Market Street Pump Station Disinfection System Upgrades
Solicitation Number: CO-00463-FG
Job No.: 21-6008

ADDENDUM 1
November 4, 2021

C OSHG ROOM SECTION
D-02 D-02 SCALE: 3/8" = 1'-0"

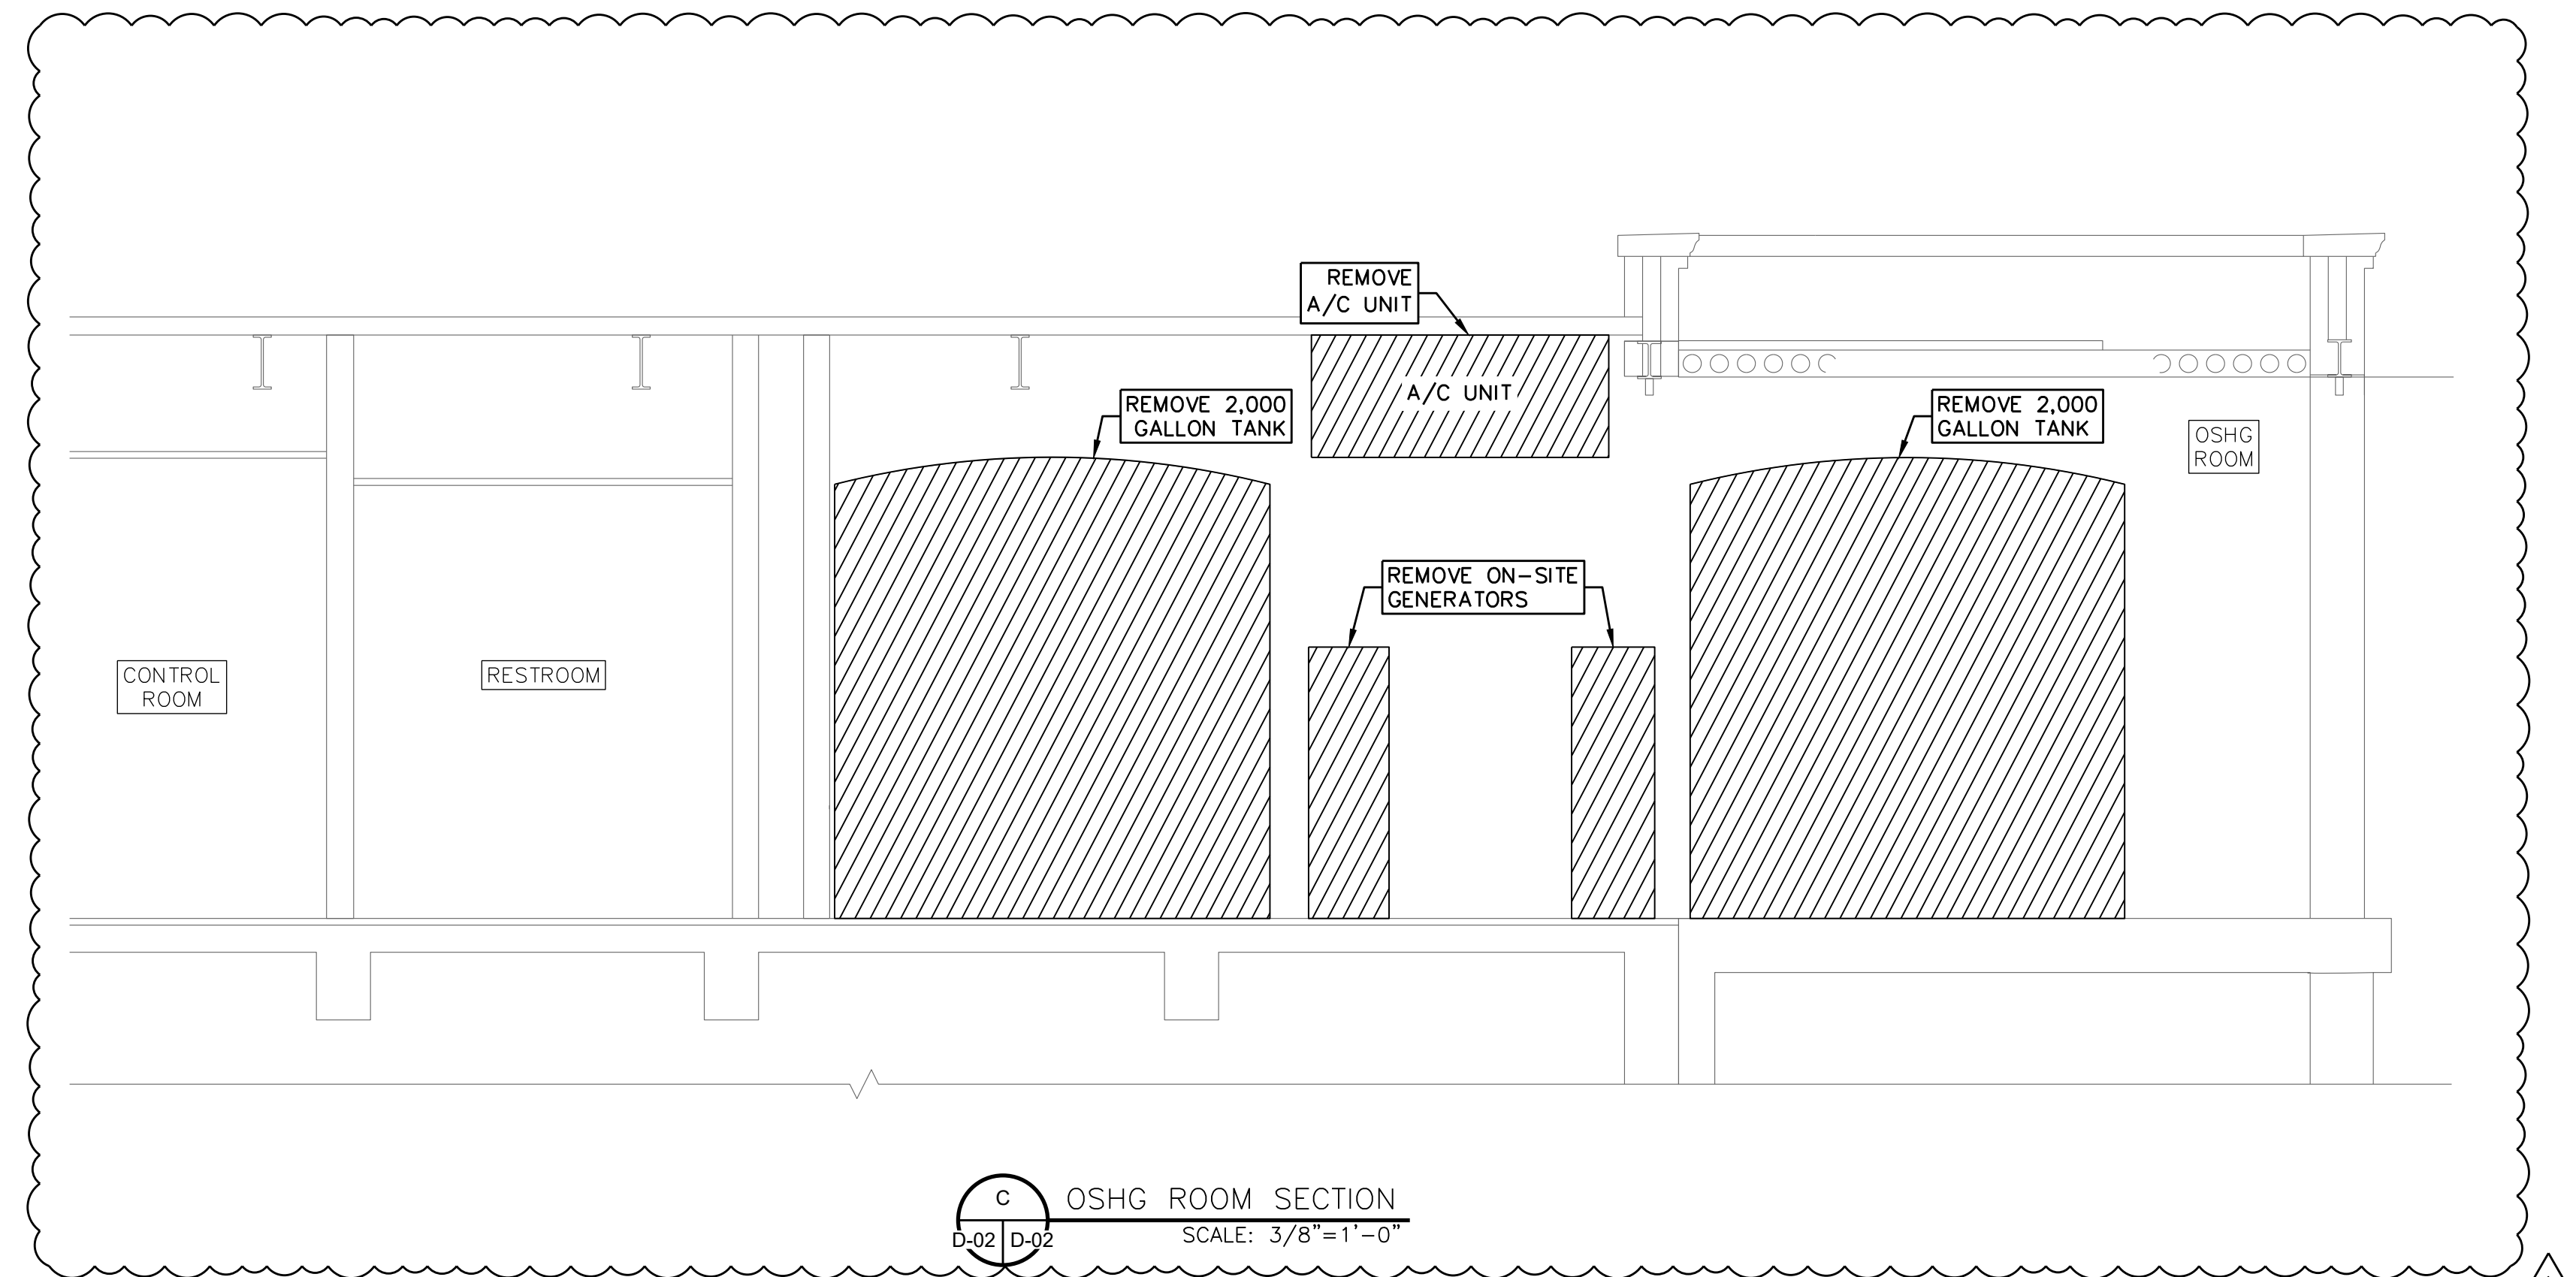
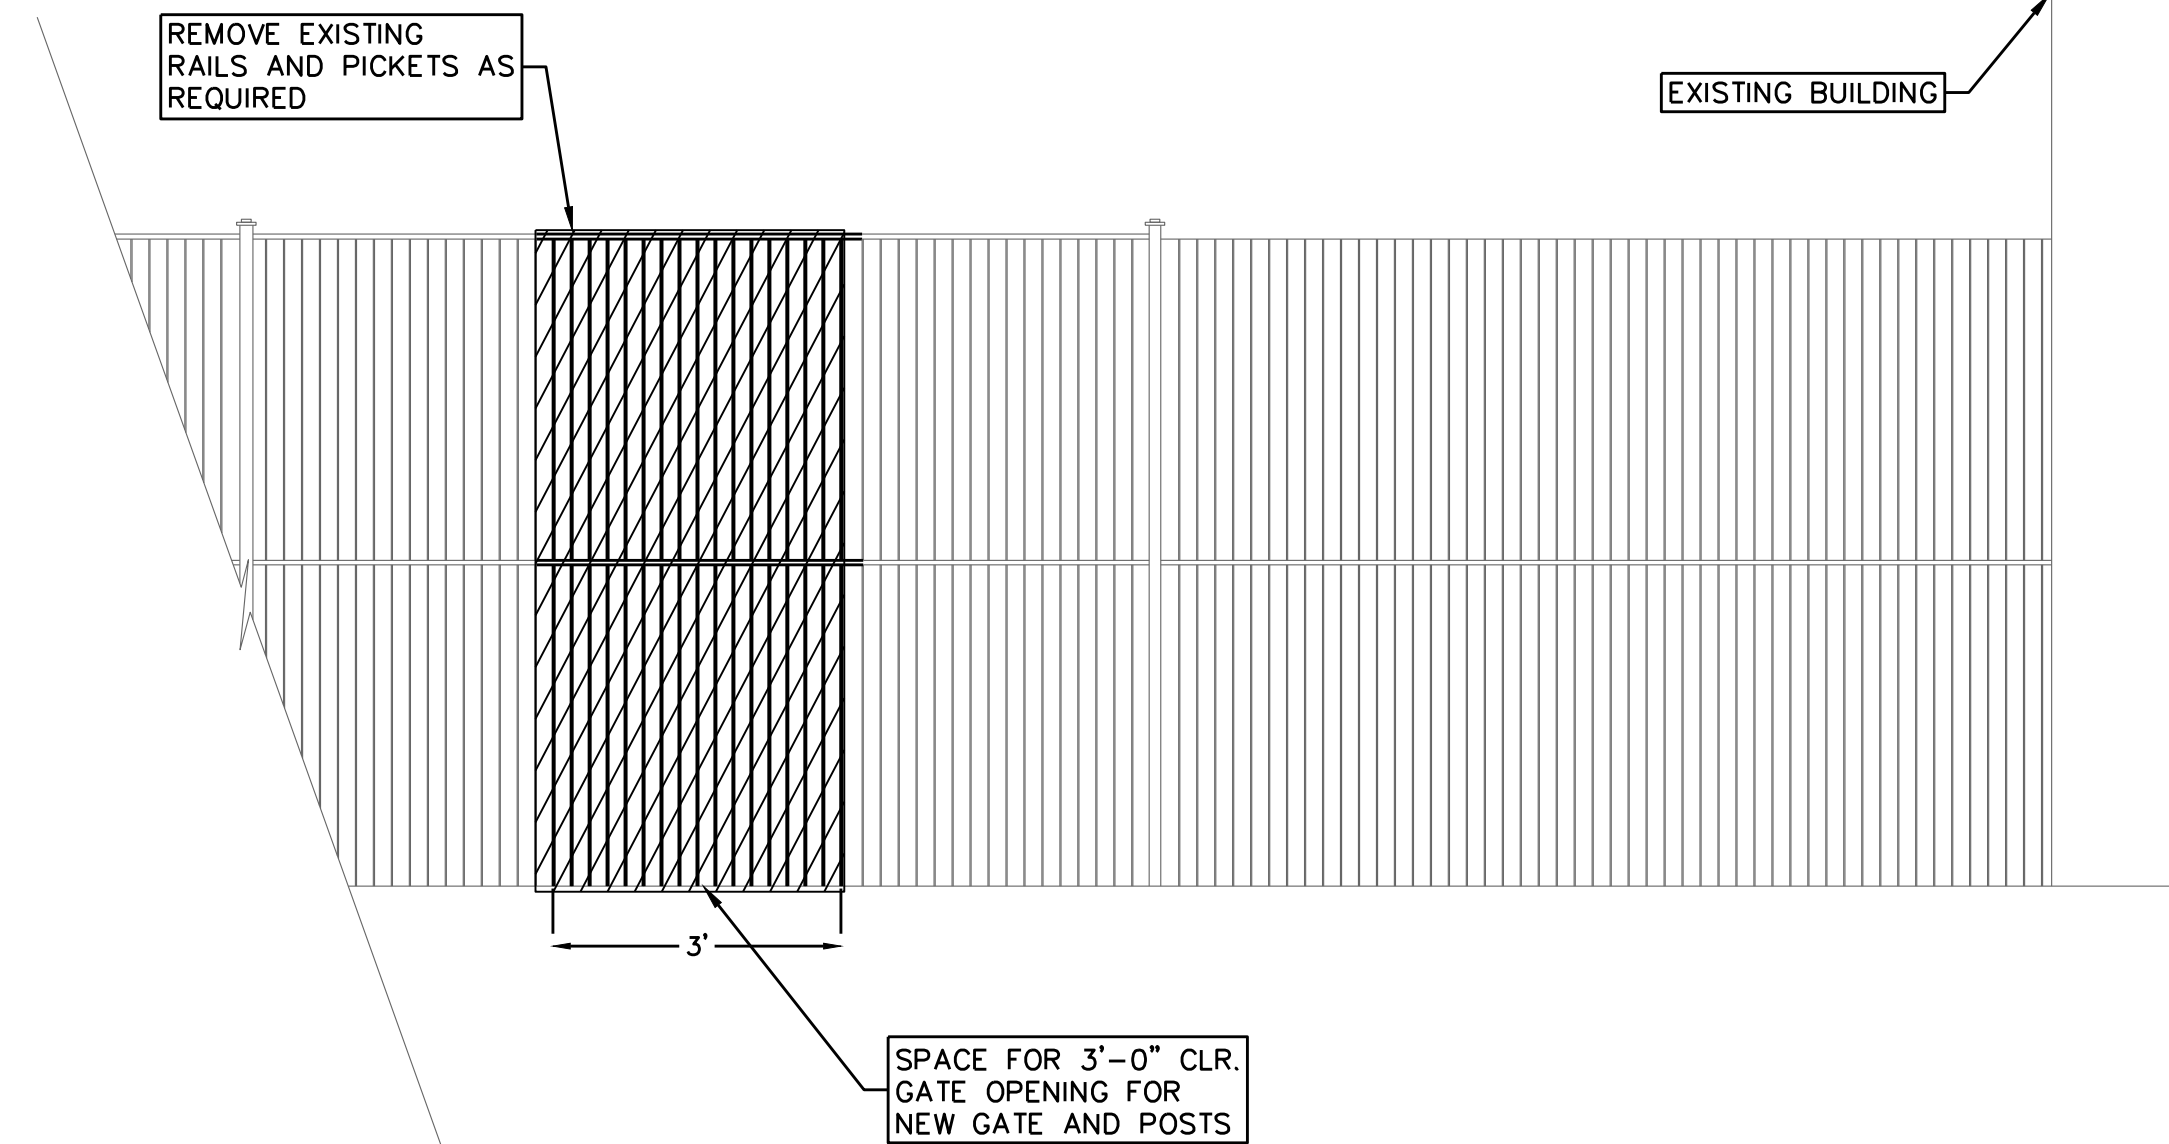
8. Question: Sheet D-02, detail C, does the cross-hatching of the parapet walls indicate demolition? What are the two hatched walls next to the tanks?

Response: No, the drawing shows several similar cross-hatching patterns for the roof parapet and internal walls, but they are to remain and will not be demolished. See the "Changes to the Plans" section below. Sheet D-02, Detail C is updated with cross-hatching only for equipment to be removed from the OSHG Room.
